Ducted Systems Technical Services Service Letter

Letter: **YS-005-2020**

Subject: **Blocked suction process tube / Suction access port on Heat Pumps**

Product: THE, YEE, TE4B, REP14L, YHE, TH4B, RHP14L, YHG, CH6B, TH6B, RHP16L, YZT, HC19B, and HL19B

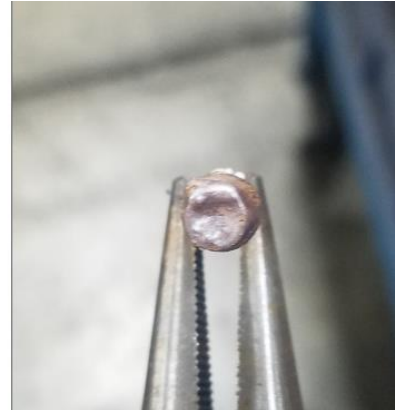
Our internal investigation revealed that the suction process tube was being brazed shut during unit build. It was determined the cause of the error was an improperly created hole in the suction line tubing where the process tube is inserted prior to brazing. Specifically, the hole appears to be pressed instead of drilled which created a "pool" as shown in the image below. During process tube brazing, on some units, the process tube would fill with brazing alloy completely sealing it off from the refrigeration circuit. On units brought back to the factory for investigation when we removed the suction process tube the suction line itself remained sealed with a "slug" of brazing alloy. See images below of sealed suction line and slug of brazing alloy removed from the suction line.

Since the currently installed suction process tube cannot be safely removed and re-inserted at the same location due to the excessive amount of brazing alloy, we have developed a kit that contains 3 different sizes of a pre-drilled copper couplings as shown to the right, replacement suction process tube, bi-flow liquid line filter drier, cable ties, and installation instructions. The blocked suction process tube will remain installed with the unit but rolled back behind the unit block off panel and secured with a cable tie. The copper coupling and replacement suction process tube will be installed in a different location between the reversing valve and compressor. Specific locations will be called out in the kit installation instructions.

We expect to have repair kits in stock at Source One very soon. If there is an immediate need to access the refrigerant circuit during heat pump heating operation, this letter authorizes the use of a SUPCO bullet piercing valve as shown to the right as a temporary means of access. There are many different piping configurations between the different heat pump models and capacities. Locate the piercing valve as close as possible to the current suction process tube preferably close to the unit base pan. The heat pump models contain either a 5/8, 3/4, or 7/8 inch suction line. Bullet piercing valves are not offered at Source One and must be field sourced. SUPCO part numbers are shown below:
